**City of Kingston**  
**Report to Kingston Heritage Properties Committee**  
**Report Number HP-25-001**

**Subject:** Application for Ontario Heritage Act Approval

**Address:** 244 James Street (P18-450)

**File Number:** P18-110-2024

DRAWING  
PRELIMINARY SITE PLAN

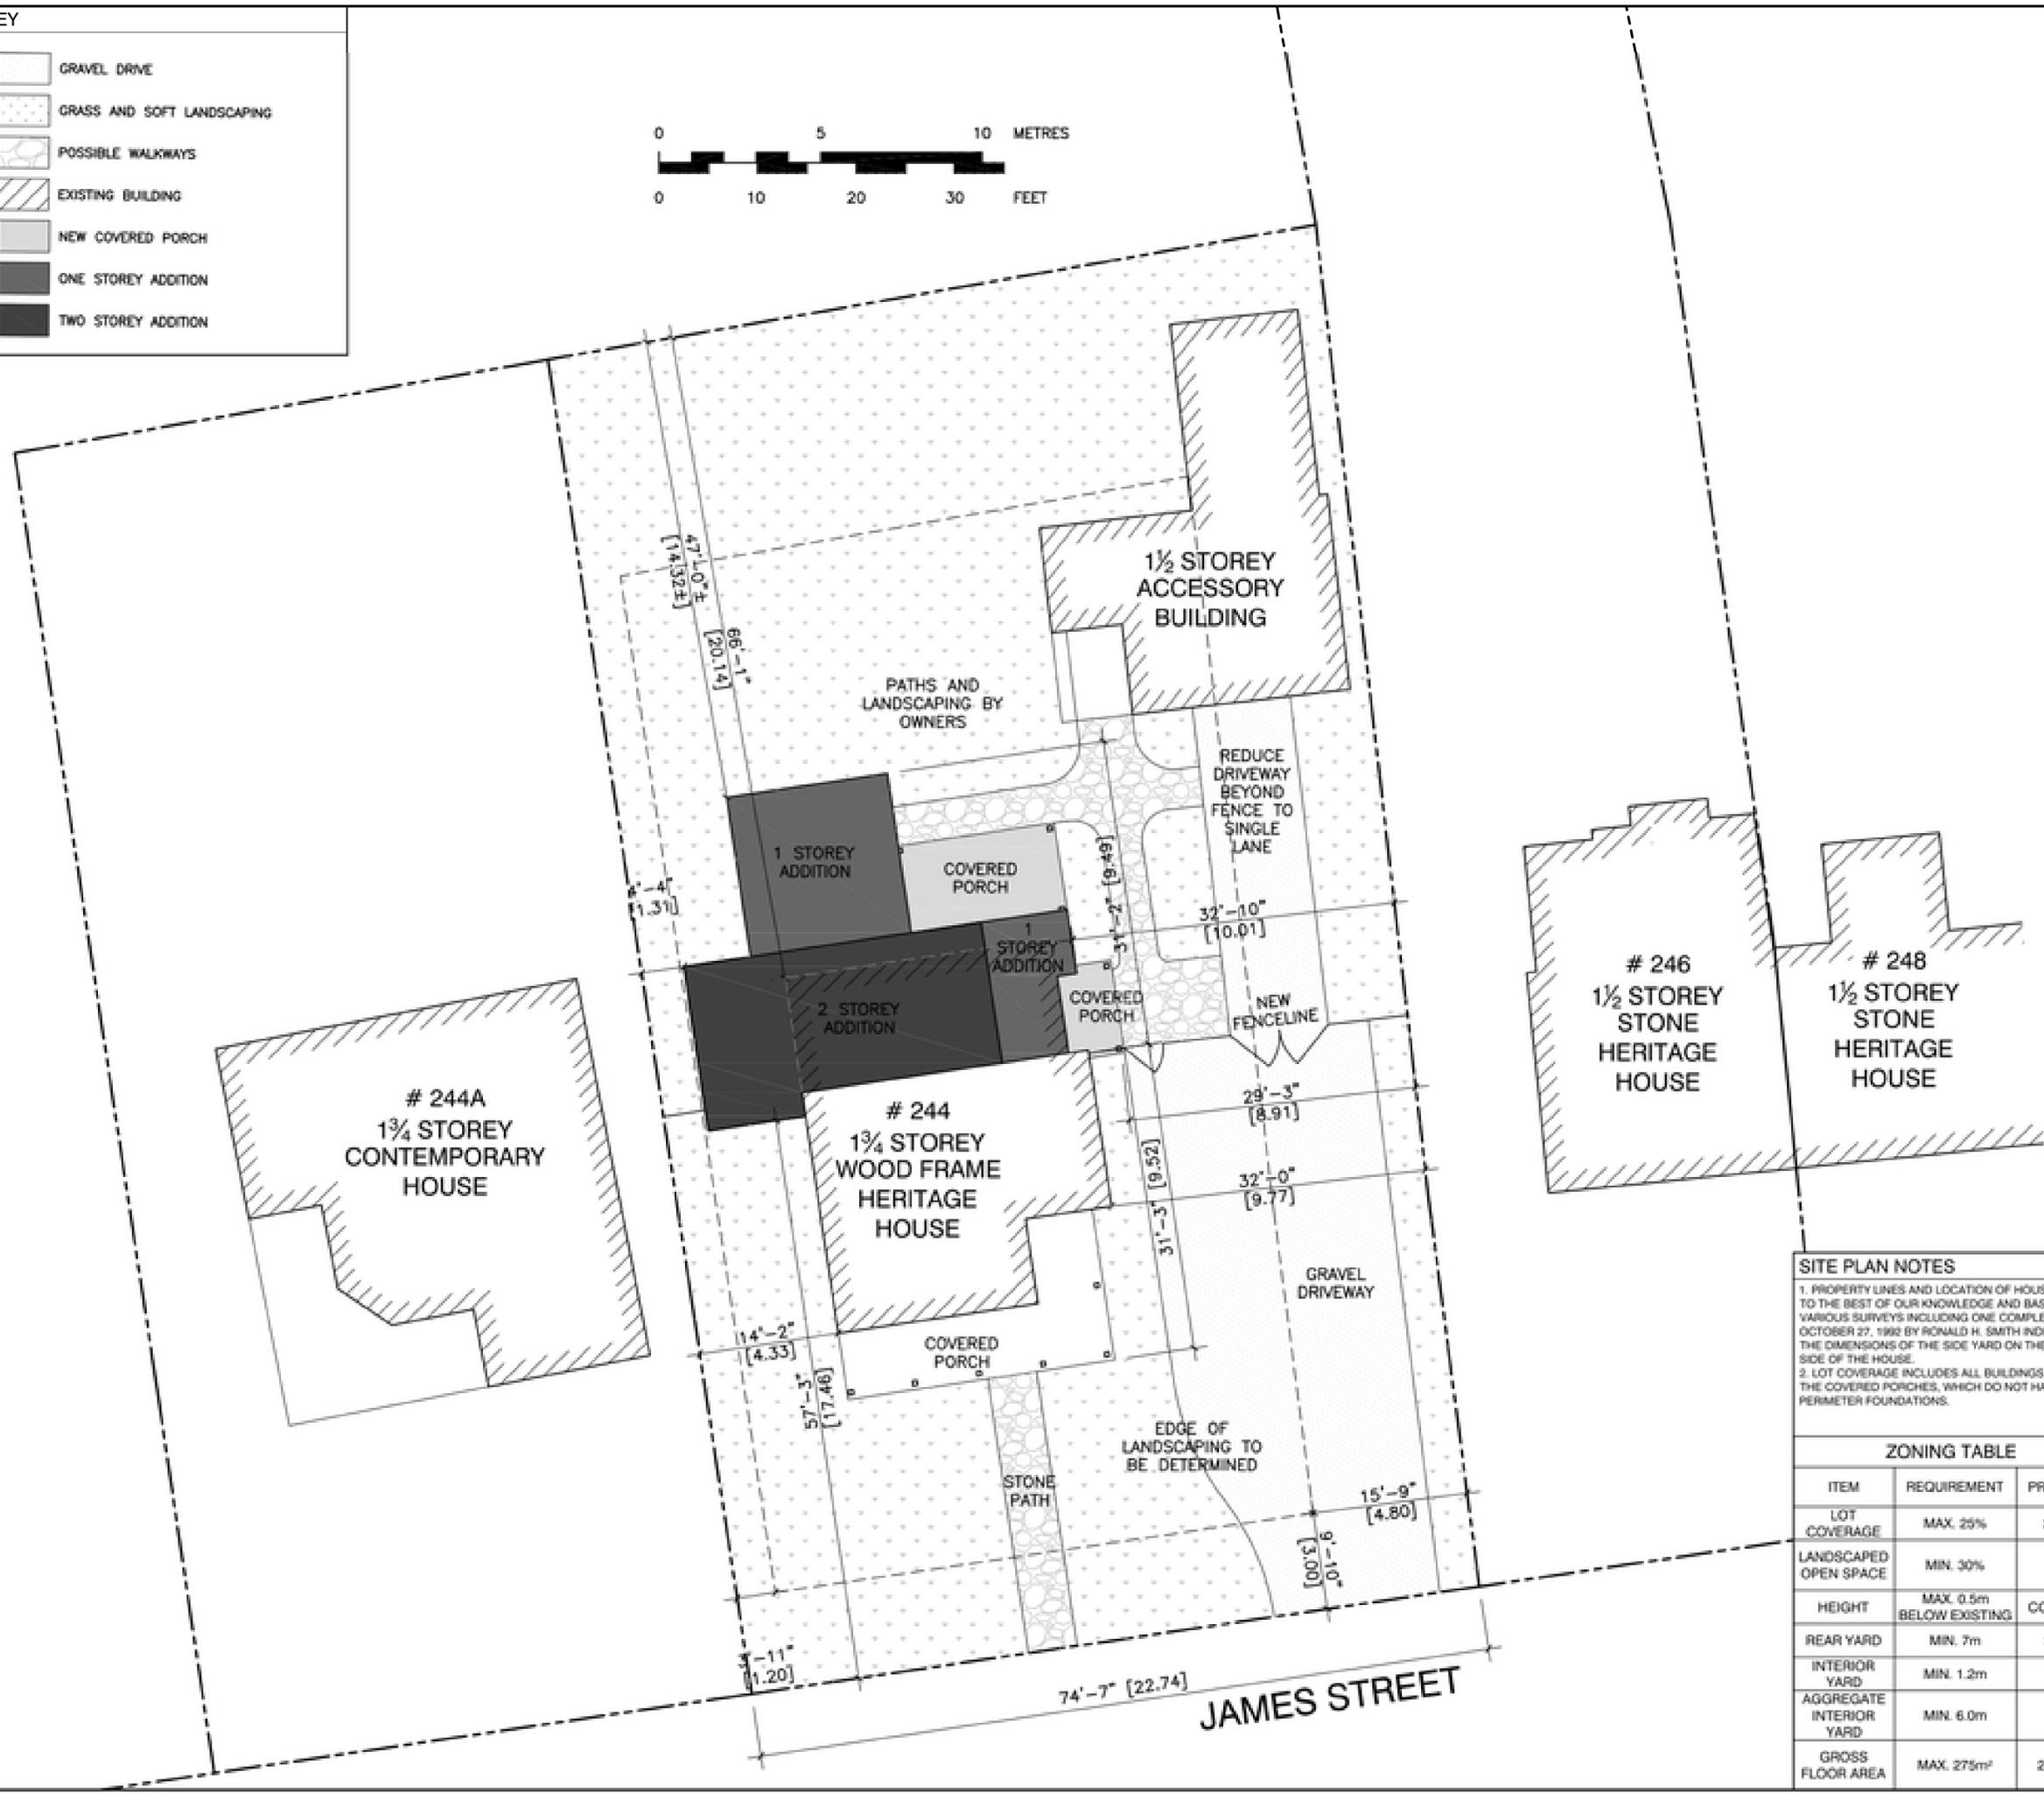
Driveway – please provide width of driveway at front lot line. The applicant is advised that the maximum driveway width at the front lot line is the lesser of 40% of the lot width or 6.0 metres as per clause 7.4.8. (5) of the zoning by-law.

Driveway – the maximum driveway width is 6.0 metres beyond the front setback as per clause 7.4.8.(6) of the zoning by-law. Please revise plans to include a maximum driveway width of 6.0 metres. Note: if the applicant is seeking to widen the driveway to accommodate one additional (2.6 metre wide by 6.0 metre long) parking space, the driveway may be widened to a maximum width of 9.0 metres beyond the front setback, provided that the property complies with the landscaped open space and all other parking requirements.

Driveway – Please provide length, width, and area of the proposed parking area and the location, length and width of all parking spaces to assess compliance with Section 7.4.8.

Driveway – the applicant is advised that parking is not permitted within the front yard (i.e. area between required front setback and front lot line) as per clause 13.2.3.(4).

DRAWING  
**PRELIMINARY ROOF PLAN**

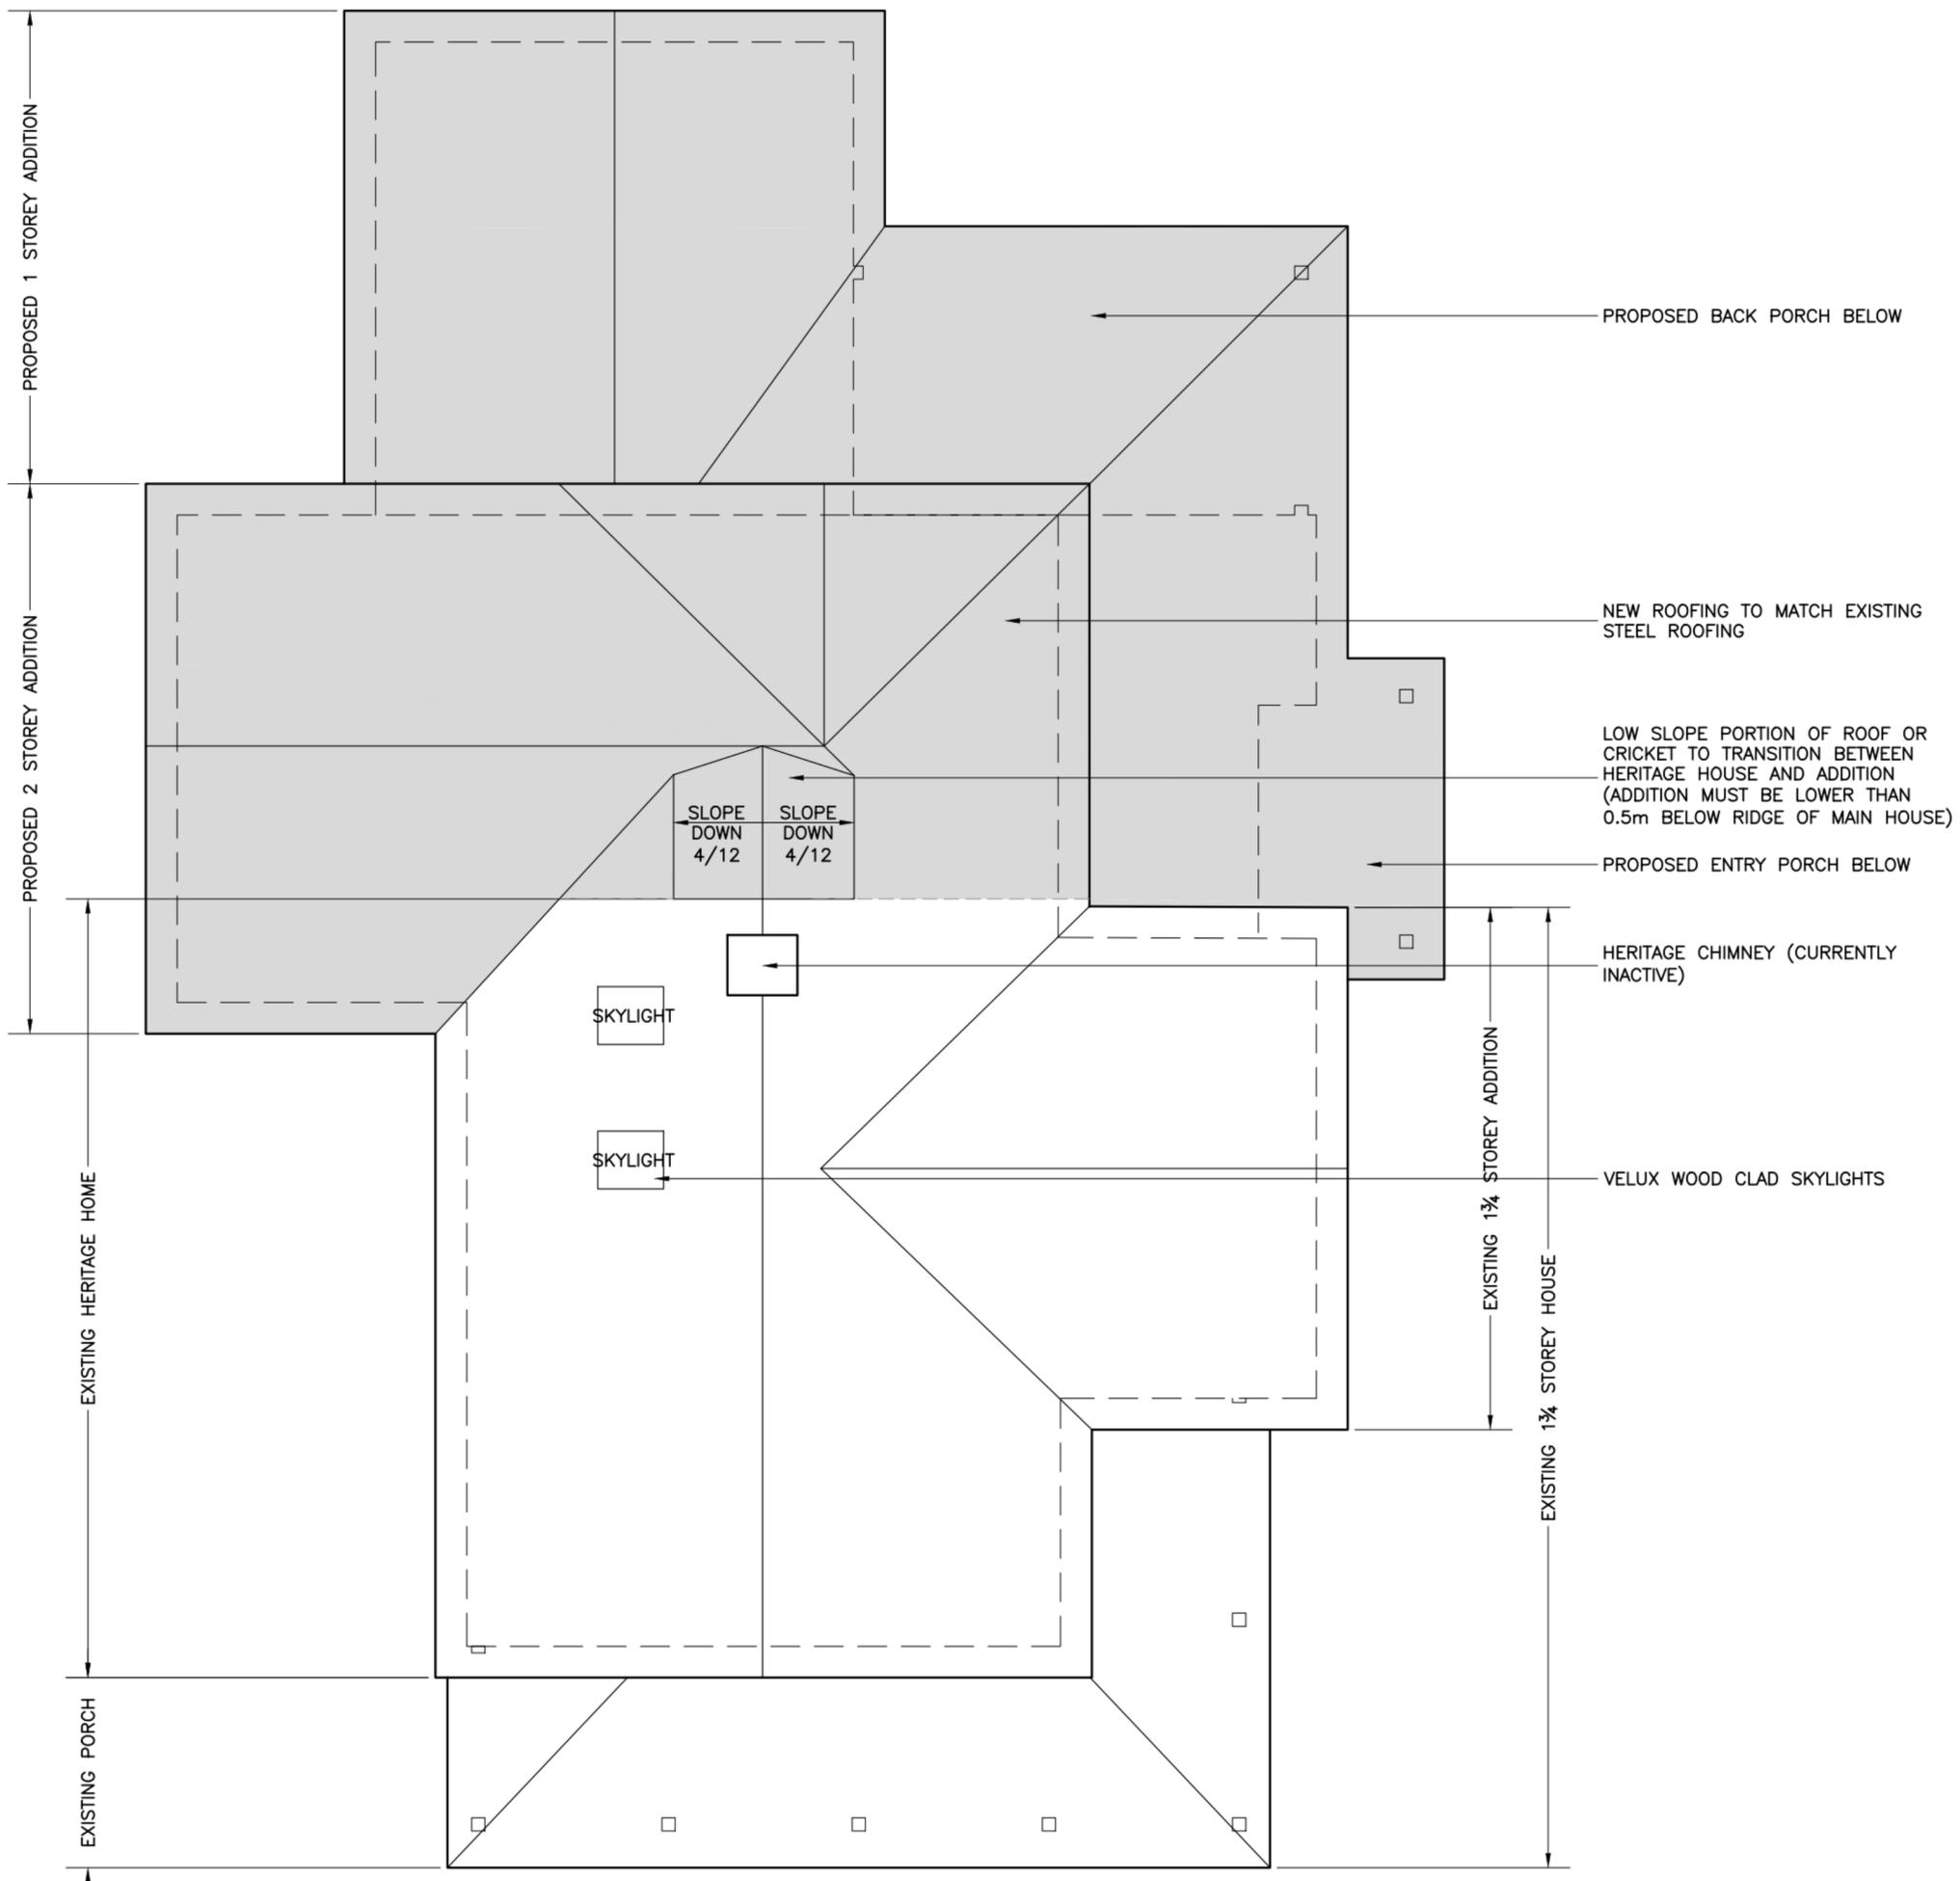
• In addition, please provide size/dimensions and any product details currently available for review for these skylights or this will be a condition of approval prior to installation.

The intention of having a couple of skylights here was to bring light into the centre of the second floor because the existing natural light will be blocked by the addition. We wanted to avoid new windows in the heritage house, and a couple of skylights near the back of the existing roof seemed a more discrete way to add natural light. Although they could be seen from the street, this didn't seem to be a very prominent location and there isn't anywhere else to put them, given that the areas to be lit are at the centre of the house.

DRAWING  
PRELIMINARY  
NORTH AND WEST  
ELEVATIONS

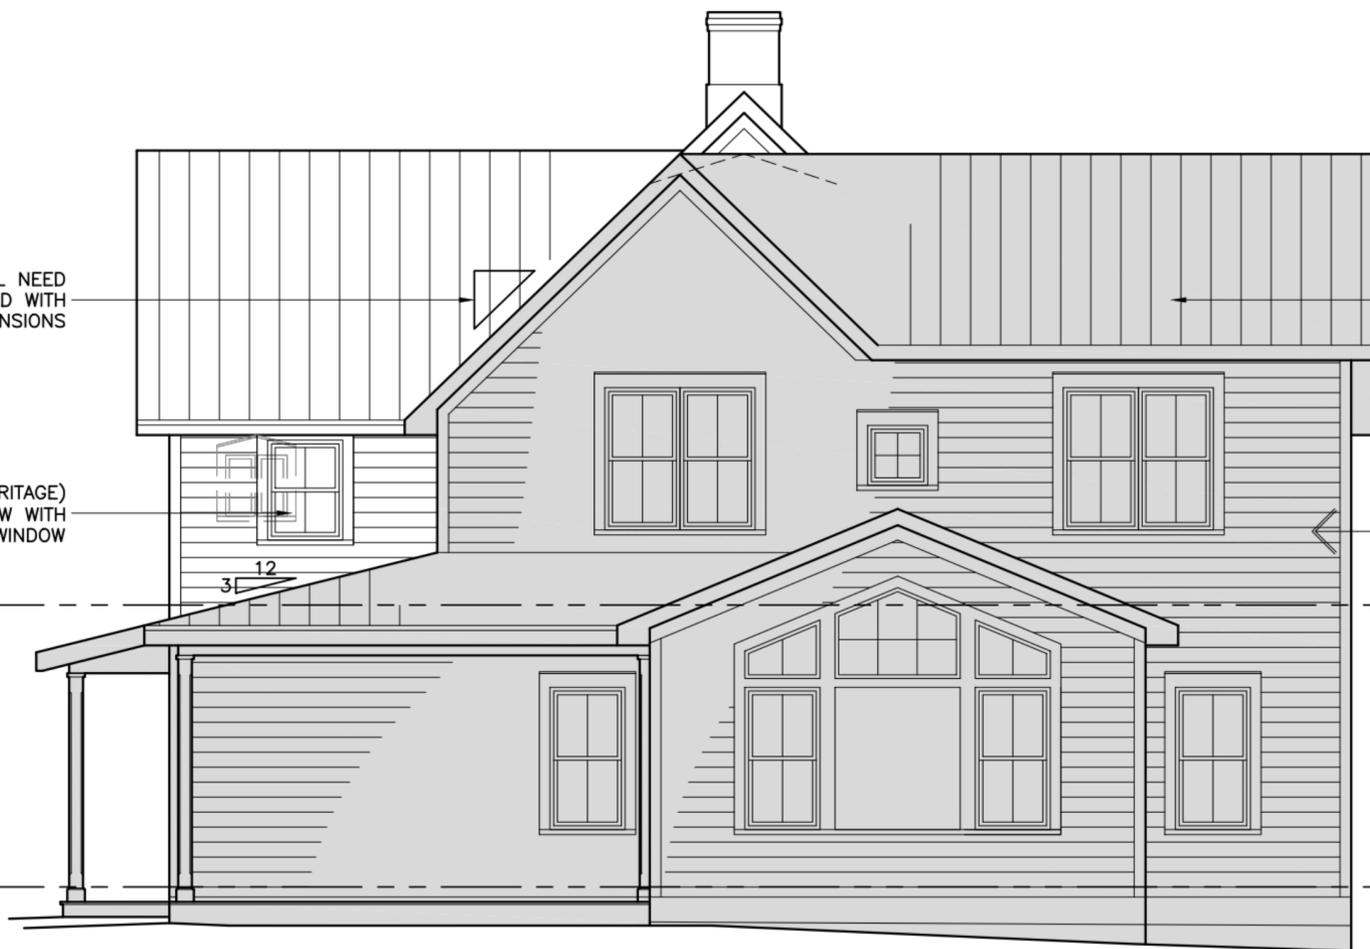
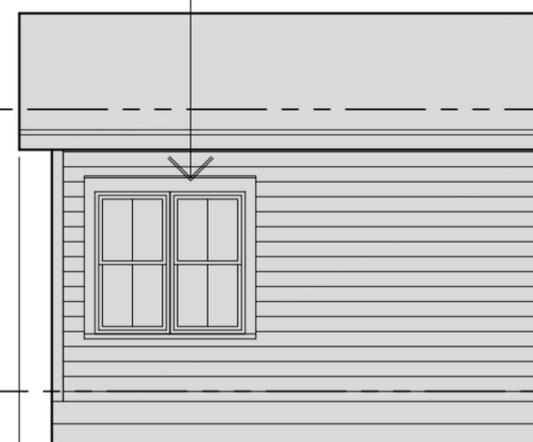
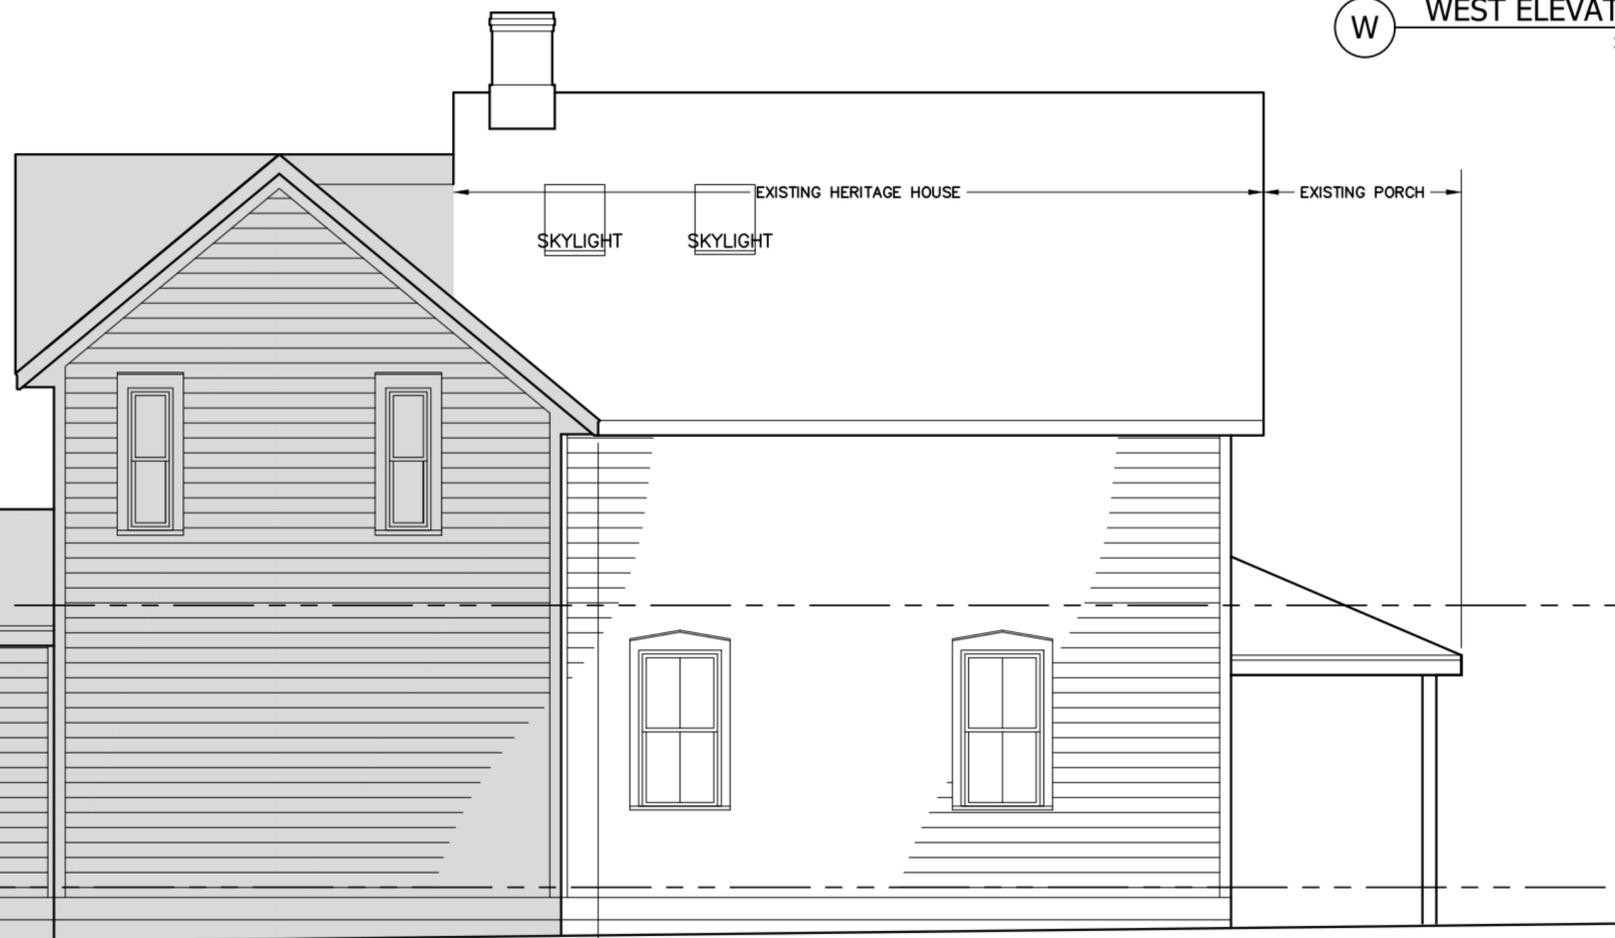
• Casement windows along public façades (i.e. those elevations visible from James Street) are less appropriate than sash windows in Barnefeld. Is it possible to change these windows to a more appropriate type? I believe this may also be cause concern with the Committee if casement windows continue to be proposed.

- single hung windows with flat trim rather than peaked (attached pdf) to help with the legibility issue
- more detail on the porch posts
- with two west bedroom single hung windows rather than the horizontal one over the bed
